October 5, 2007

**Re: Addendum to Supplemental Sampling and Engineering Design
Report for Re-routing of Sanitary and Storm Sewer Pipelines
GE-Pittsfield/Housatonic River Site
Hill 78 On-Plant Consolidation Area (GECD210)**

GENERAL ELECTRIC COMPANY
 PITTSFIELD, MASSACHUSETTS
ADDENDUM TO SS/ED REPORT
EXISTING SOIL BORING
LOCATIONS AND PROPOSED
SEWER RE-ROUTING

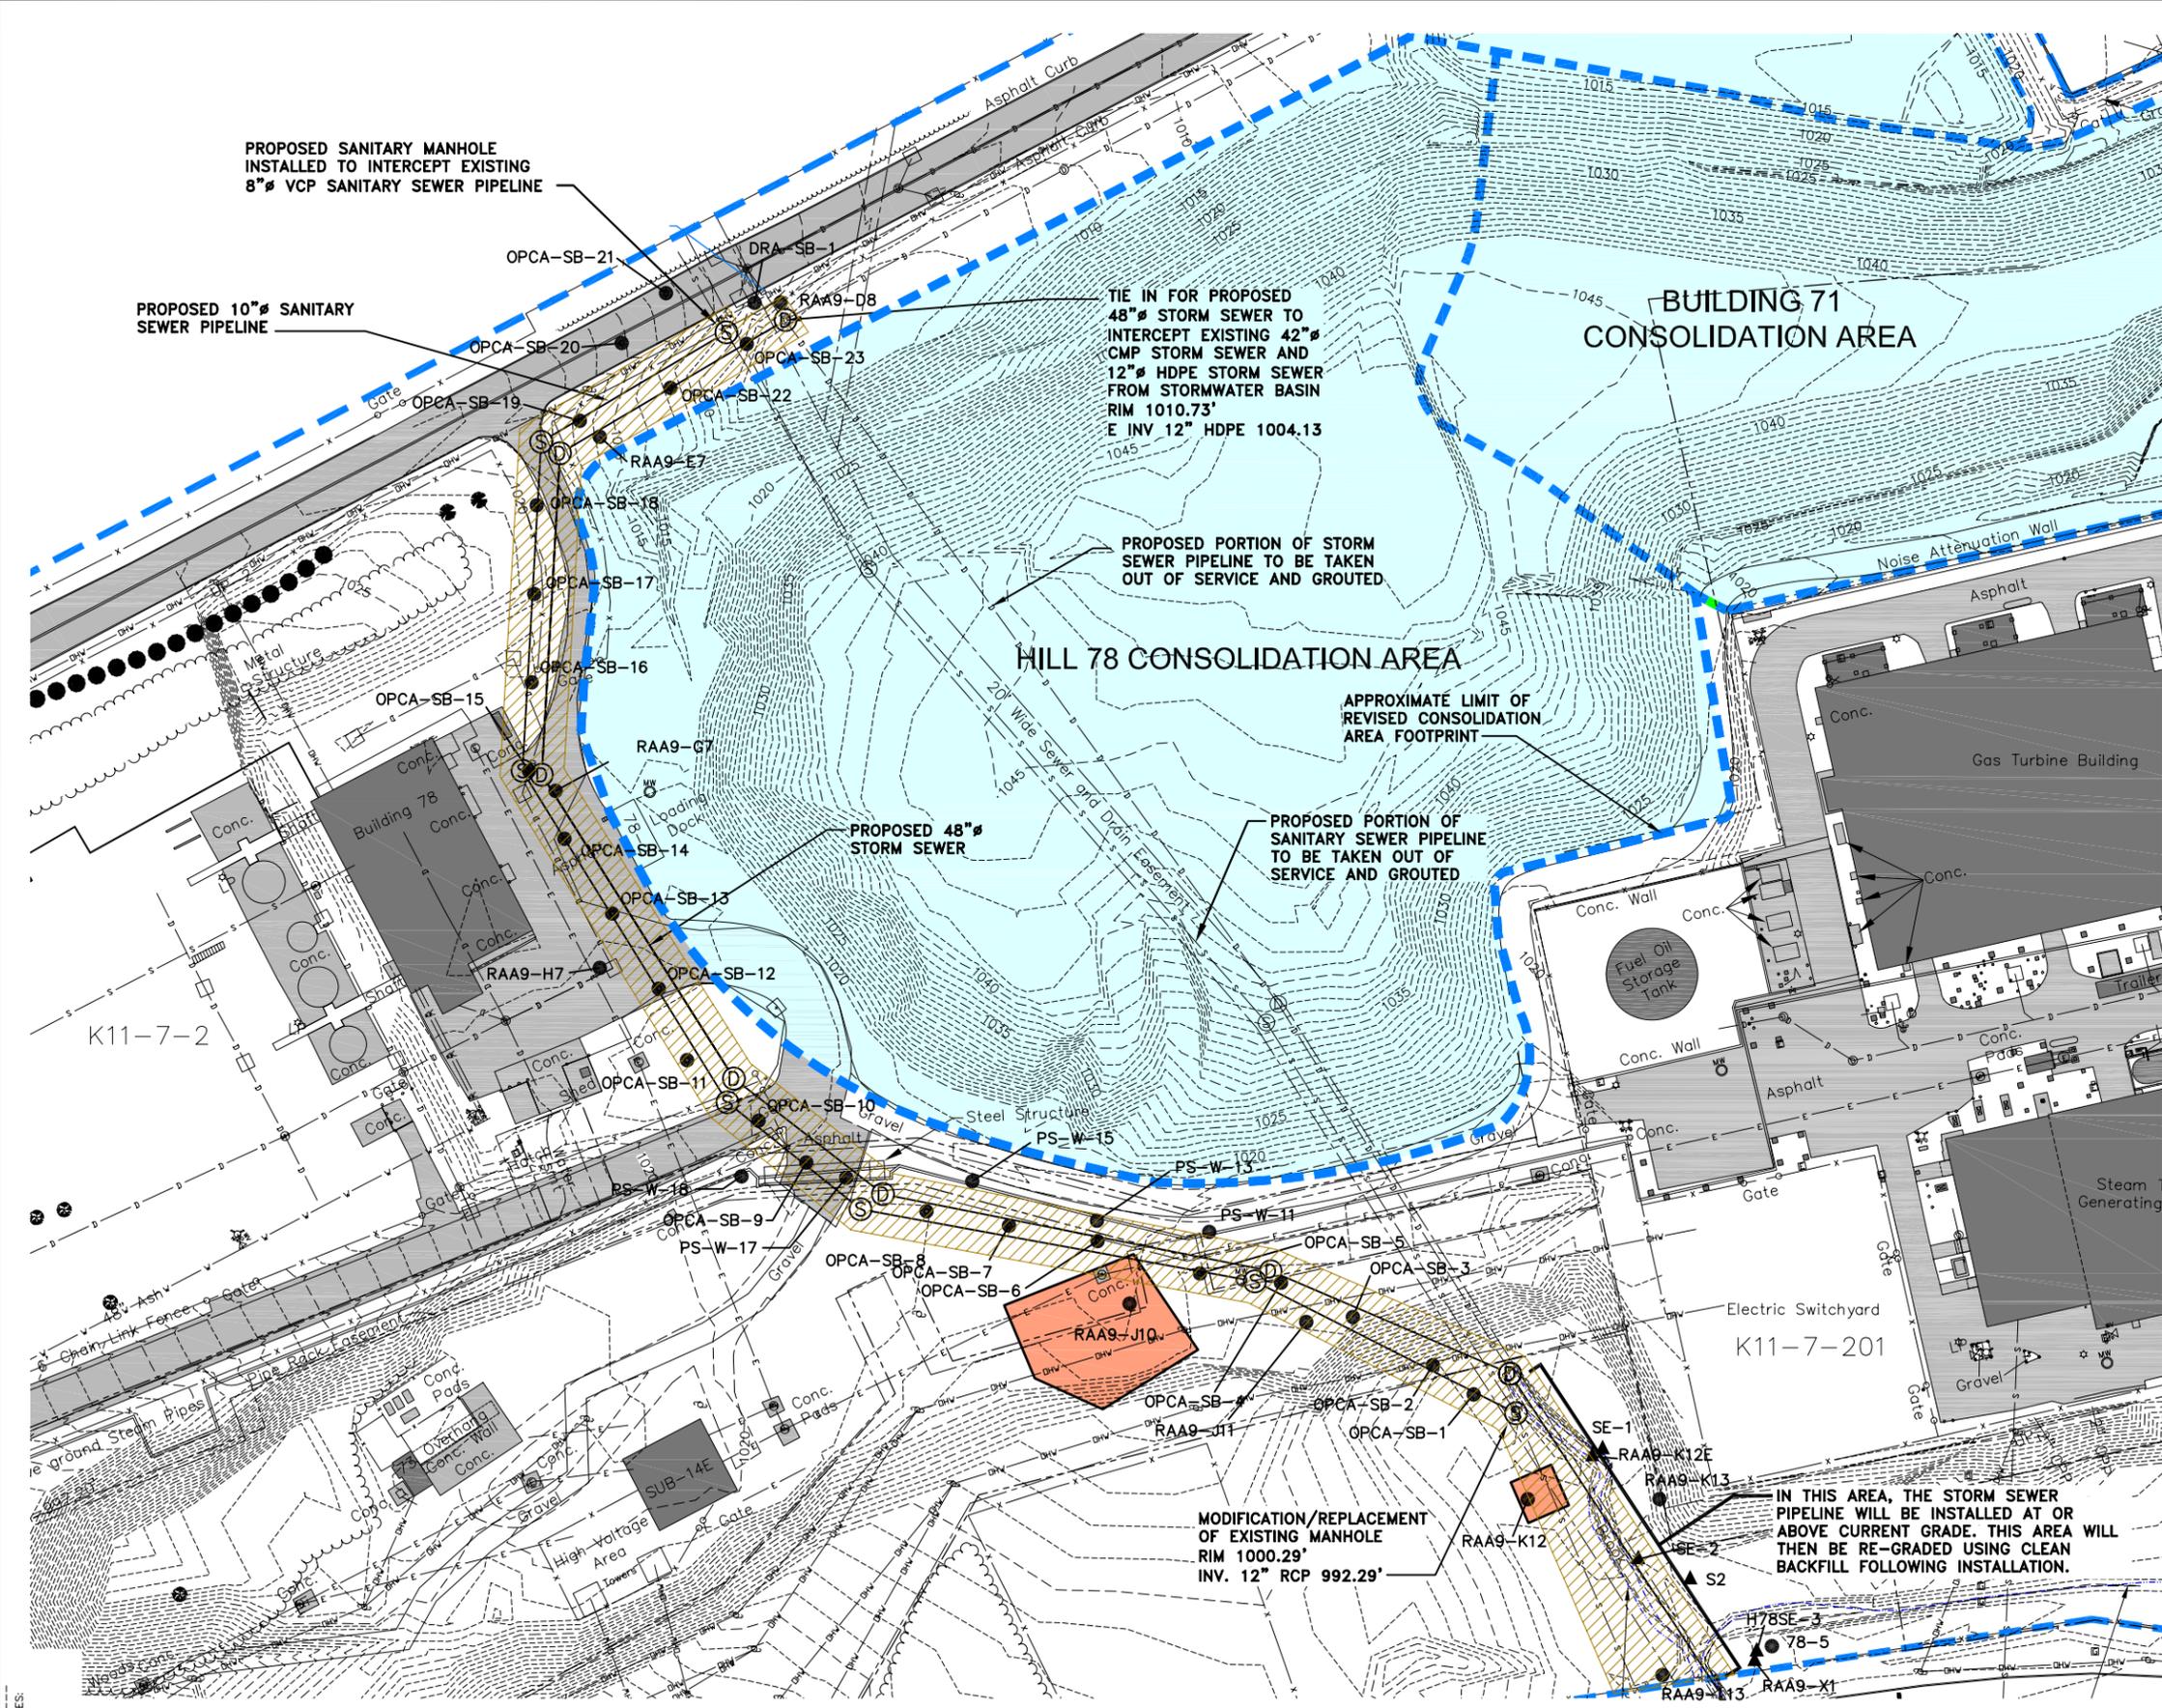
GE shall specify how the excavated material will be segregated and backfilled such that soil currently in the 0-1 foot, 1-6 foot and 6-15 foot depth intervals will be backfilled in the same interval and same general location. Alternatively, GE shall provide an explanation as to how the backfilling, if not performed as described above, will impact the characterization of the Hill 78 Remainder RAA and the subsequent Conceptual RD/RA evaluation.

As part of the characterization of the soils located within the proposed storm and sanitary sewer corridors, GE did not include sample results from the area where it is proposing to extend the storm sewer above ground beyond the location where it “daylights”. Accordingly, GE shall confirm that no remediation is required for the proposed work area beginning where the storm sewer pipeline currently daylights extending all the way to the RAA boundary.

The evaluations presented in the SS/ED Report indicated that, of the 81 PCB samples collected in the area to be excavated, the single highest detected PCB concentration was 30 parts per million (ppm). This concentration, detected at sample location OPCA-SB-7 (0-1'), as shown on Figure 1, is only marginally greater than the most stringent PCB Performance Standard applicable to the Hill 78 Remainder RAA, as specified in Appendix E of the CD, the *Statement of Work for Removal Actions Outside the River (SOW)*. Specifically, this single maximum PCB concentration of 30 ppm, taken on its own without averaging this result with the lower results from other samples, is very close to 25 ppm, which is the Performance Standard for the average PCB concentration in the 0- to 1-foot depth increment at this RAA. This sample is also far less than the Not-to-Exceed concentration of 125 ppm applicable to this RAA. Further, the calculated spatial average PCB concentration for the soils within the utility corridor (0.63 ppm) is far below these Performance Standards. As a result, segregation of the soils within each depth interval is not necessary to ensure that such soils are replaced within the corresponding depth increments from which they were removed.

GE has reviewed the PCB and Appendix IX+3 soil sample data collected in the vicinity of the location at which the re-routed storm sewer pipeline will be installed above current grade (i.e., the portion of the re-routed storm sewer beyond the location where it currently “daylights” south of the Hill 78 OPCA). These PCB and Appendix IX+3 soil sample data are presented in Tables 1 and 2, respectively. These sampling locations are presented on Figure 1.

As indicated on Table 1, the maximum PCB concentration of 3.7 ppm (with a duplicate of 3.5 ppm) at location H78SE-3 is well below the PCB Performance Standards applicable to the Hill 78-Remainder RAA (i.e., 25 ppm [0-1’], 200 ppm [1-6’], 100 ppm [0-15’], and an NTE value of 125 ppm). As a result, no future response actions will be necessary in the vicinity of the re-routed pipelines to address PCBs in soil.

Based on an initial review of the Appendix IX+3 soil sample data in the vicinity of the above-grade portion of the re-routed storm sewer, GE has performed a preliminary evaluation of the Appendix IX+3 soil sample data for the Hill 78-Remainder RAA using the procedures applicable to this RAA (as specified in the SOW) and which will be utilized in the forthcoming Conceptual RD/RA Work Plan. The results of that preliminary evaluation indicate that no future response actions will be necessary in the vicinity of the re-routed pipelines to address Appendix IX+3 constituents in soil. Nevertheless, as a conservative measure, based on discussions with EPA, GE has elected to remove soils associated with sampling location RAA9-K12, which has elevated concentrations of certain polycyclic aromatic hydrocarbons in the sample collected from the 0- to 1-foot depth increment. Specifically, GE is proposing to remove soils associated with this sampling location from the approximate 25-foot by 25-foot area illustrated on Figure 1 and Technical Drawing 2 in Attachment A.

Technical Drawing 2

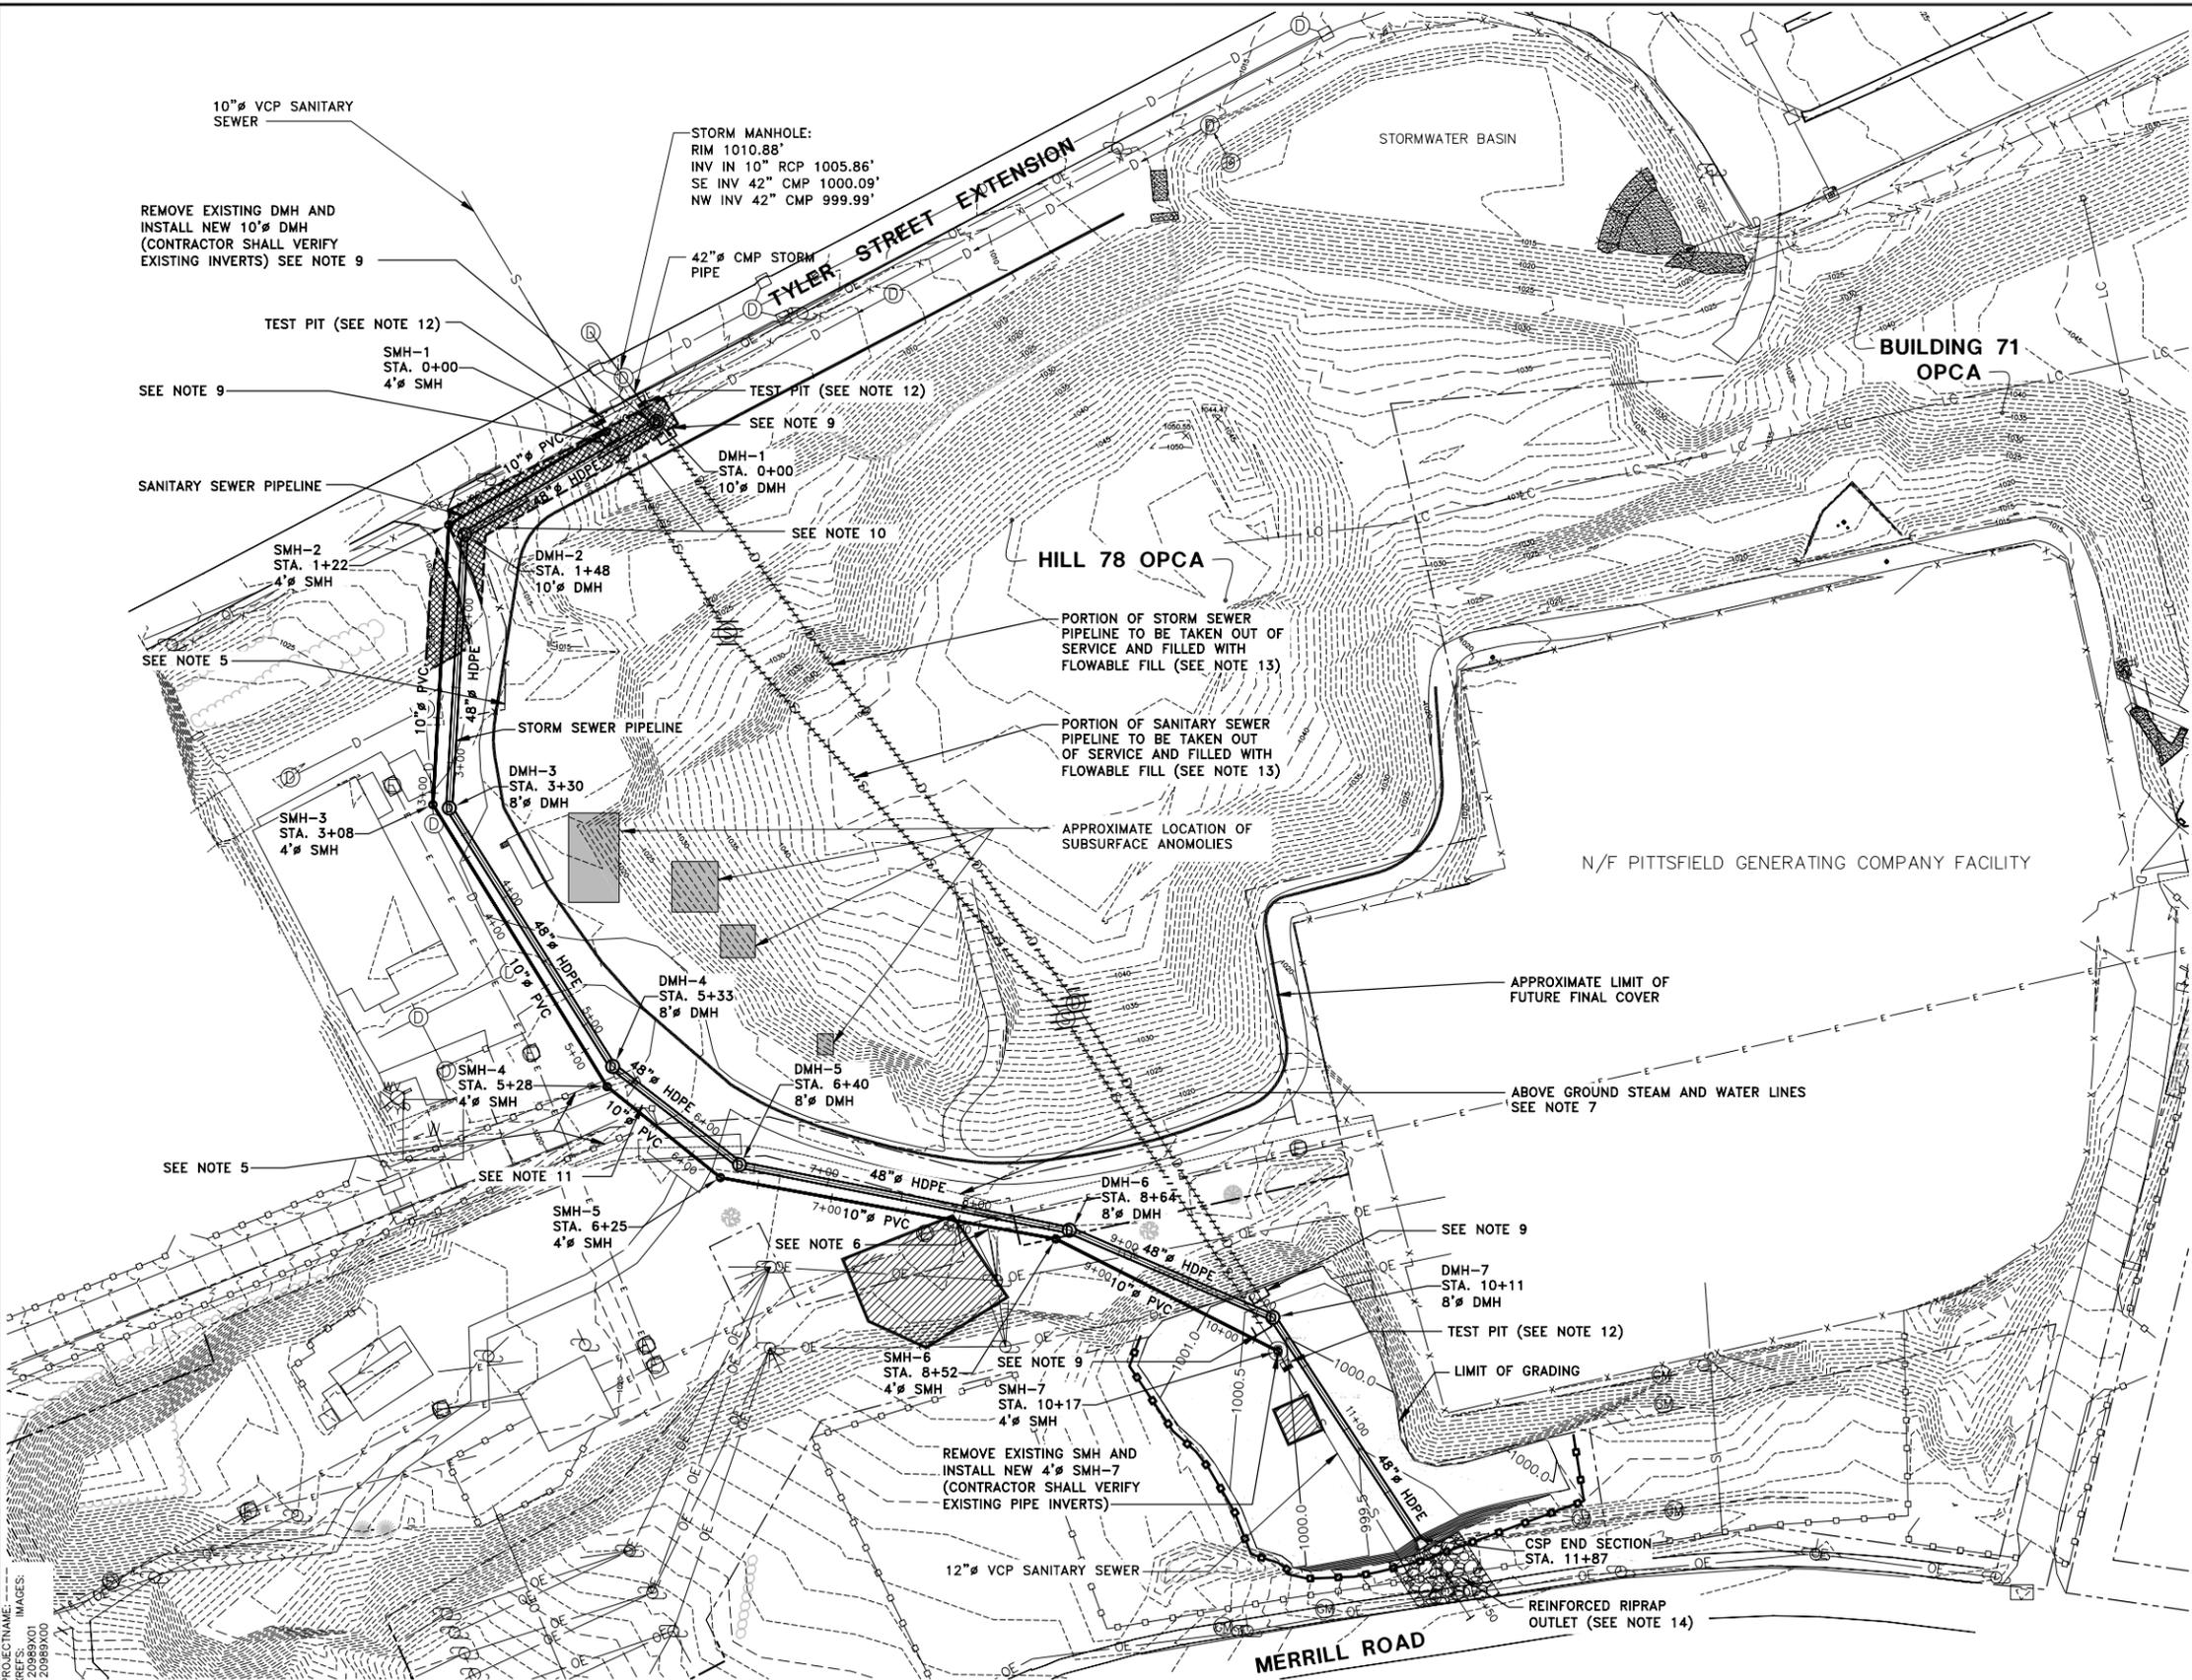
GE shall remove all soils within the polygon associated with location RAA9-J10, to a depth of one foot, prior to the initiation of any excavation or stockpiling activities associated with the sewer rerouting project, and not just the portion of the polygon that falls within the new utility corridor. If the Hill 78 Remainder remediation occurs prior to the sewer rerouting project, the removal shall occur as part of the Hill 78 Remainder remediation.

GE shall specify what clearing and restoration activities will occur as part of the rerouting of the sewer, including the extent of tree removal associated with the project and plans for restoration and replacement. The plans for tree restoration and replacement associated with the rerouting of the sewers shall be incorporated into the plan for tree restoration and replacement activities being prepared in accordance with the requirements of conditions #1 and #5 of EPA's June 19, 2007 conditional approval letter for GE's April 13, 2007 submittal titled Hill 78 On-Plant Consolidation Area Phase III Final Cover Installation Activities.

Soil within the polygon associated with location RAA9-J10 will be removed to a depth of one foot prior to initiation of re-routing activities (as illustrated on Technical Drawing 2 in Attachment A). If the remediation for the rest of the Hill 78-Remainder Removal Action Area (RAA) occurs prior to the re-routing activities, the excavation will occur as part of that remediation.

Clearing activities for the re-routing project will occur at certain areas near Tyler Street Extension as illustrated on Technical Drawing 2 in Attachment A. Construction activities in this area will require the removal of five large spruce trees. Following installation of the sanitary and storm sewer pipelines in the area identified, restoration activities will consist of topsoiling, fertilizing, and seeding. GE will incorporate any tree restoration and replacement activities as part of the planting of additional trees and shrubs along Tyler Street Extension required in Conditions #1 and #5 of EPA's June 19, 2007 conditional approval letter for GE's April 13, 2007 submittal entitled *Hill 78 On-Plant Consolidation Area Phase III Final Cover Installation Activities*.
